UNITED STATES
NUCLEAR REGULATORY COMMISSION
WASHINGTON, D. C. 20555

SAFETY EVALUATION

H. B. ROBINSON UNIT NO. 2

THE EFFECTS OF TORNADOES ON THE AVAILABILITY OF THE AUXILIARY
FEEDWATER AND SERVICE WATER SYSTEM

FIG. 1

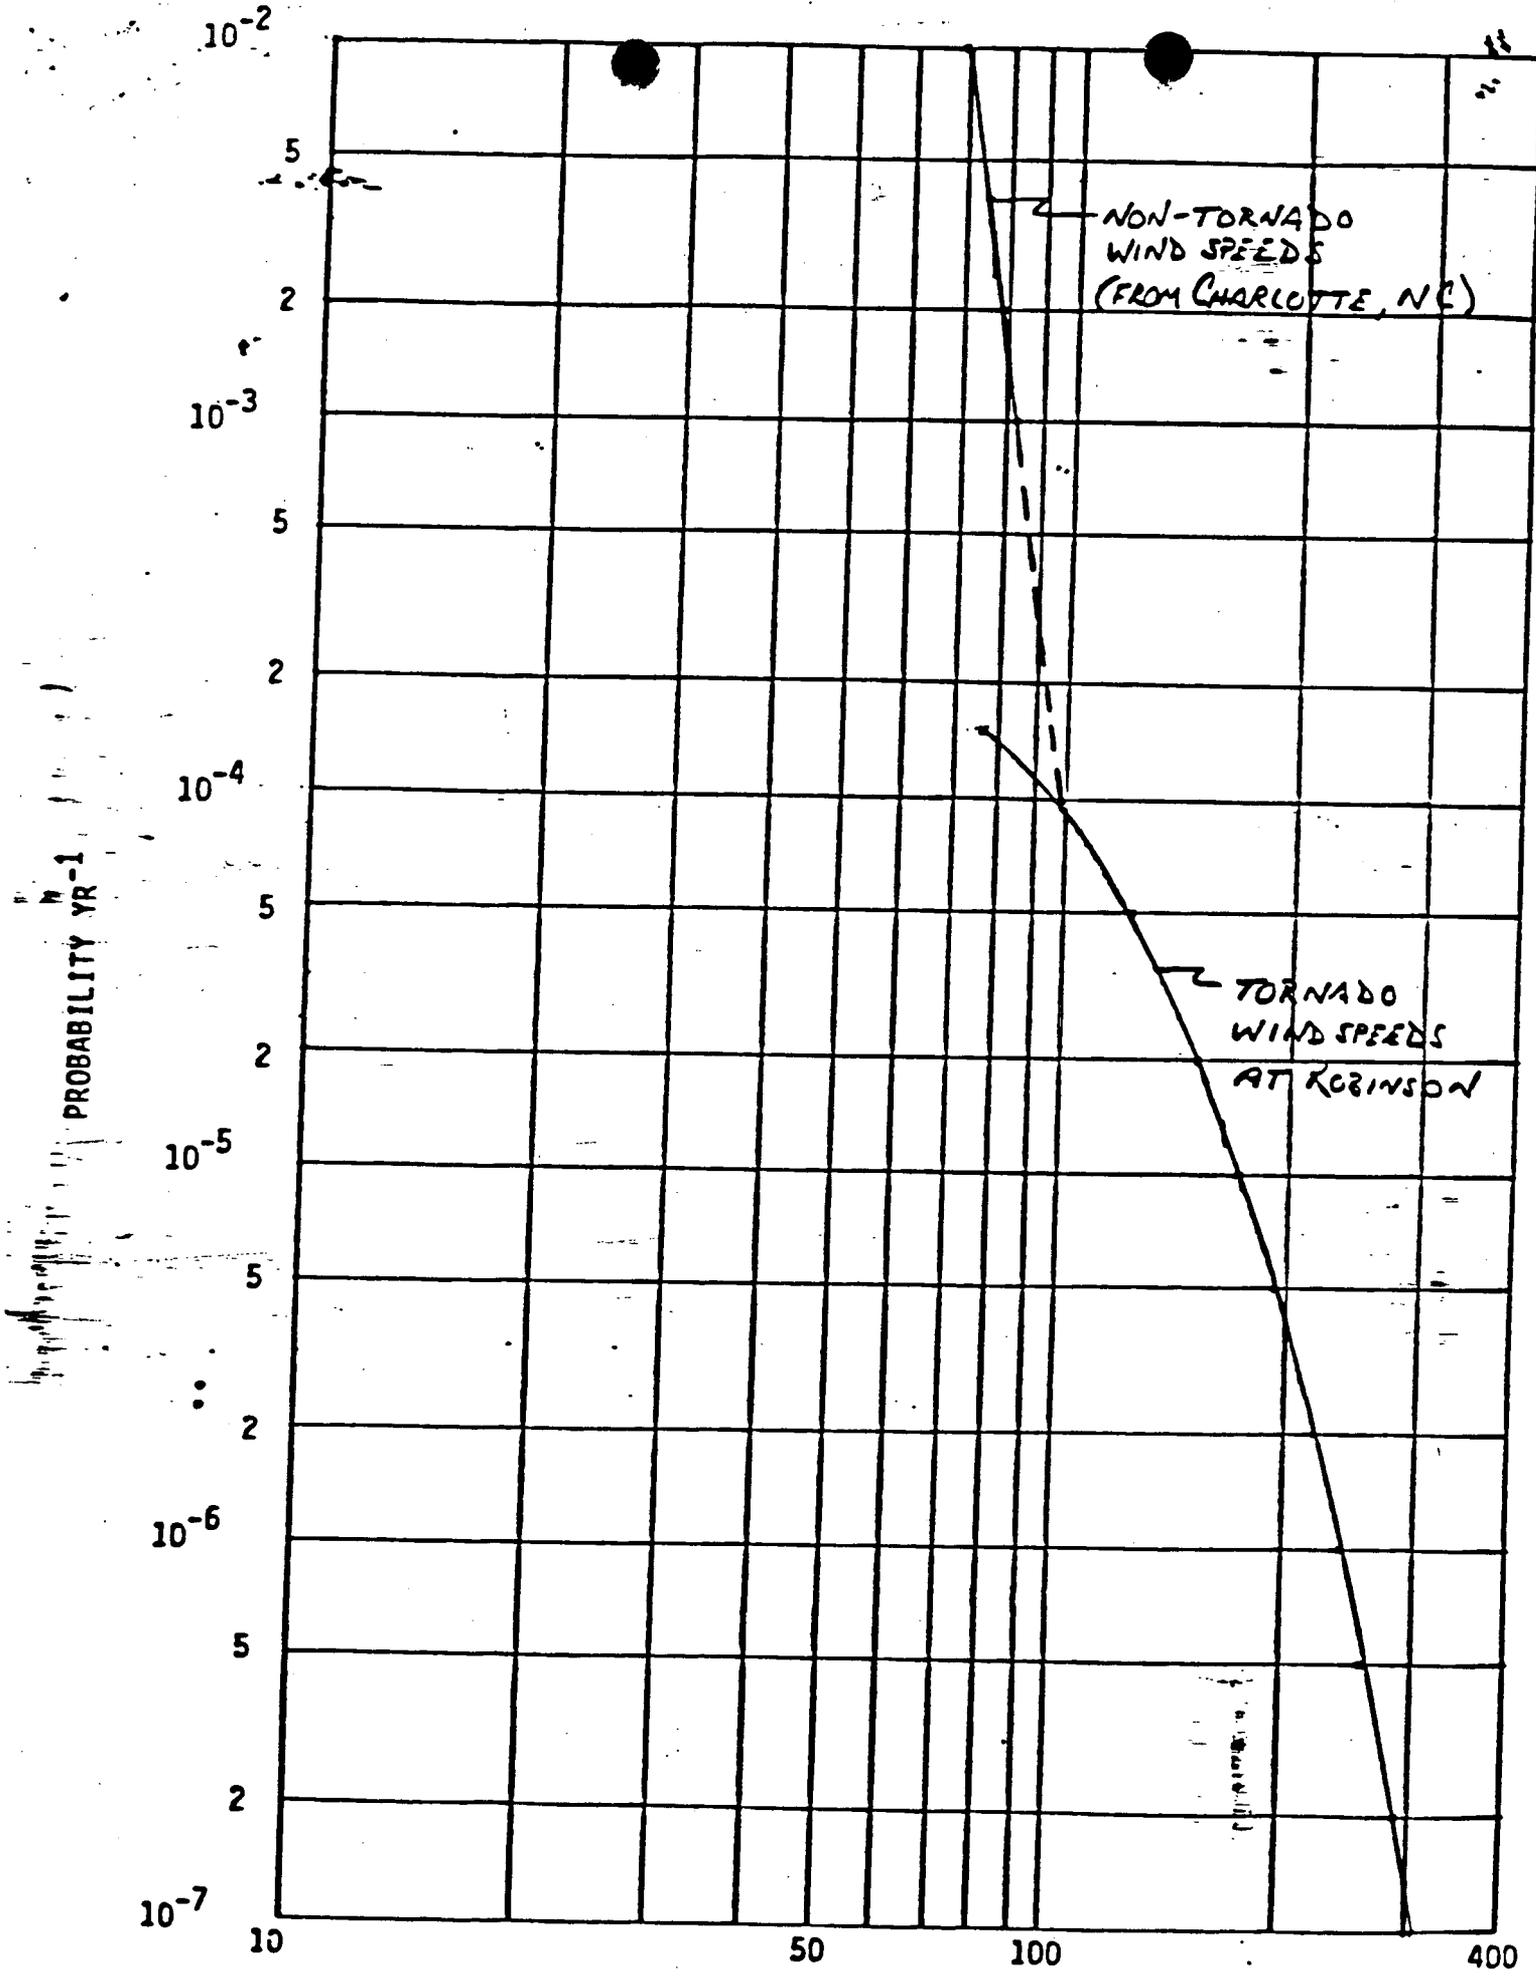
According to assumption 1, Sect. 3, $P(O) = P(W)$. According to the Report, $P(W) = 1.9 \times 10^{-4}$ per year (due only to tornadoes). However, according to memorandum Docket No. 50-261 from William P. Gamill to Olan D. Parr, dated June 12, 1982 on Tornado and Extreme Wind Frequencies for H. B. Robinson Plant (TAC # 49223), winds in excess of 73 mph due to non-tornadic phenomena are more likely than those due to tornadoes, so that $P(W) = 3 \times 10^{-3}$ per year (see Fig. 1). Since, according to assumption ⁵ Sect. 3, $P(E) = 10^{-3}$, it follows from Eq. 1 that

Equation 3a holds because the occurrence of the extreme winds that result in the failure of the Condensate Storage Tank also causes the loss of offsite power. Equation 3b and 3c follow from assumptions 12 and 3, Sect. 3, respectively. According to the Report, $P(F_3) = 1.55 \times 10^{-6}$ per year. However, according to Fig. 1, $P(F_3) = 10^{-5}$ per year. From Eq. 3c and assumption 4 it then follows that

The assumptions listed in the Report (see Sect. 3 of this evaluation) are acceptable from the point of view of their conservatism, as is the assumption that failure of the Service Water System Motors entails failure of the Auxiliary Feedwater System even if the Condensate Storage Tank were available. The mathematical approach is also acceptable. However, the reviewer feels that the data are incomplete in that nontornadic wind speed information is not included. Indeed, probabilities $P(O)$ and $P(W)$ are determined by the occurrence of nontornadic winds (see Fig. 1).

$$\begin{aligned} P_f &= P(O,E) + P(O,A) + P(O,C,\bar{S},M) \\ &\quad + P(O,S) \\ &= 3 \times 10^{-6} + 3 \times 10^{-7} + \frac{5}{6} 10^{-7} + 10^{-5} \\ &= 1.34 \times 10^{-5} \text{ per year} \end{aligned}$$

This is about one order of magnitude higher than the probability of failure estimated in the Report.
